Comments Re: application HGY/2022/4449

Location: Flat B, 118 Inderwick Road, Hornsey London, N89JY

Proposal: Enlargement of existing rear dormer including the relocation of 1x rooflight, formation of roof terrace with 1x rooflight and creation of Juliet Balcony

From: 120 Inderwick Road, London N8 9JY (Miss Victoria Nunn and Mr Imad Fattuhi)

Pictures 1 -5: Views from loft bedroom of proposed location of roof terrace, to demonstrate how the roof terrace would have significant implication on privacy, line of sight, overbearing nature and noise (arrows noting location of roof terrace)

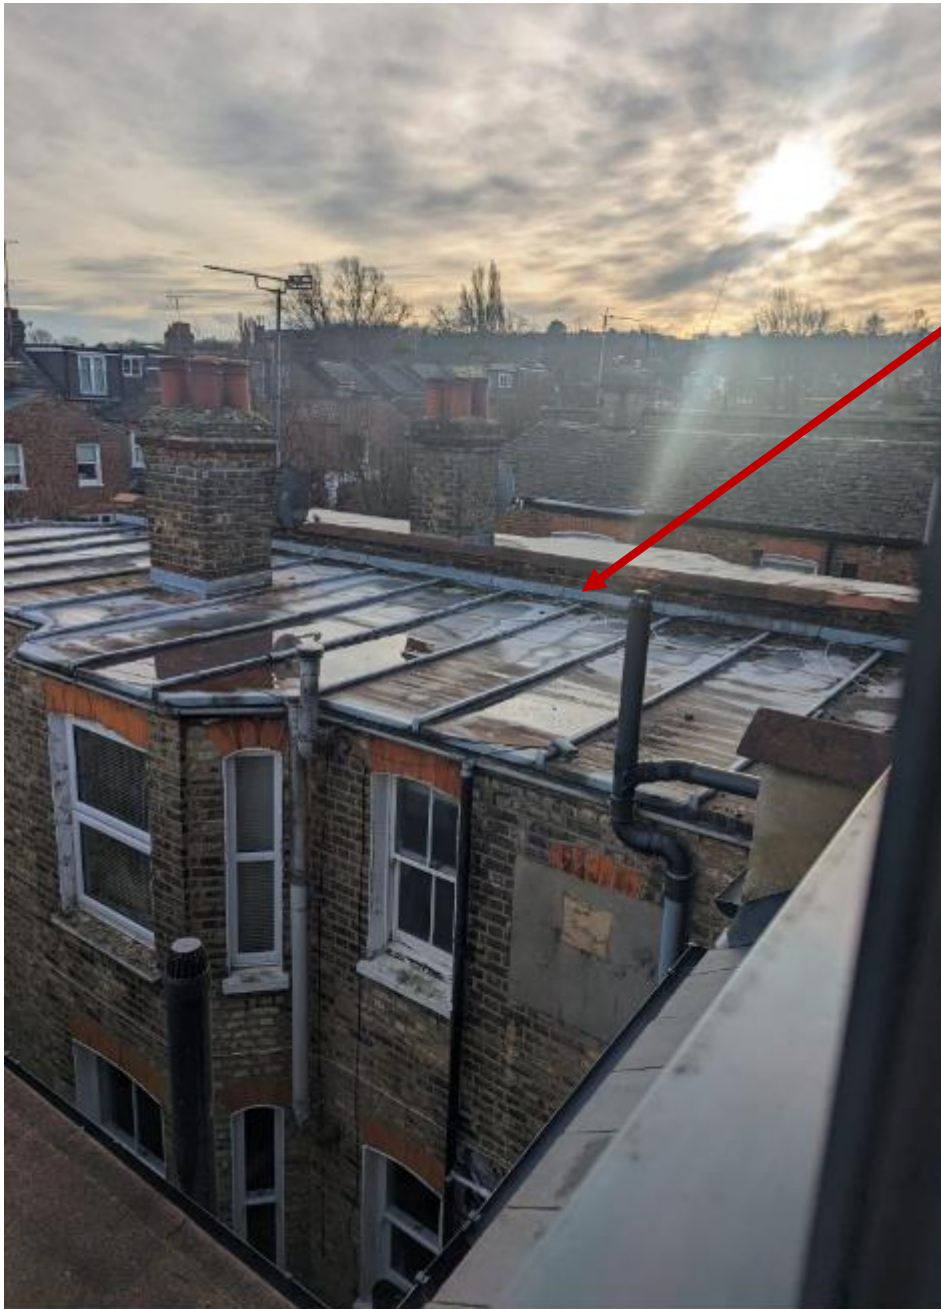
Principle: The proposed rear roof terrace raises concern of potential overlooking and disturbance, and the applicants attempts to mitigate the impact through provision of a very large frosted balustrade which would in turn create issues of overbearing impact, increasing sense of enclosure and potentially impact on daylight and outlook.

- Currently there is no access to the roof and as such this is significant change of use of the space which impacts our property
- The proposed roof terrace would have a bedroom window approximately 2 metres from my daughter's bedroom window

- The roof terrace will look directly into our rear bedroom (in which our young daughter sleeps) and loft bedroom, creating a loss of privacy and overlooking.

- The height or closeness of the roof terrace and height of the balustrade is overbearing and would be such that unreasonable overshadowing would occur.

- Activity on the roof terrace could also be loud and cause noise and disturbance to both bedrooms
- The roof terrace will also be unsightly from the loft room and change the outlook significantly

- The extremely high glass balustrade will create a sense of enclosure from the rear bedrooms and also the bay in our kitchen, potentially impacting on daylight, especially with reference to the first floor rear bedroom (photographs attached)
